Product Change Notification

Control No. PCN-11111

March 15, 2011

Fig. 1 (a) Top view of eSOP (K) package with the current pin-out configuration.

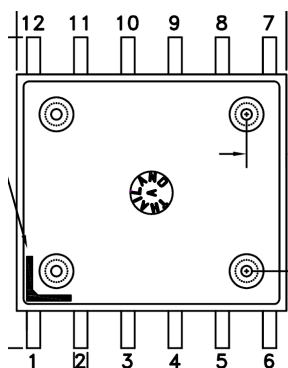
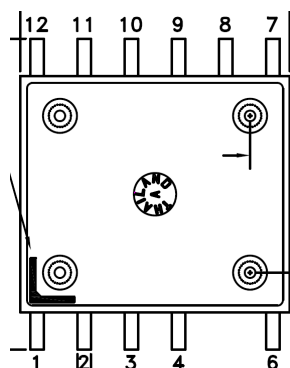
DESCRIPTION OF THE CHANGE: The pin configuration of all products in eDIP and eSOP packages is being modified. The modification is to eliminate an unconnected pin (pin 5) in order to improve creepage between the high-voltage pin (pin 6) and the adjacent pin. See the figures below for illustration of the changes.

Fig. 1 (b) Top view of eSOP (K) package with the new pin pin-out configuration
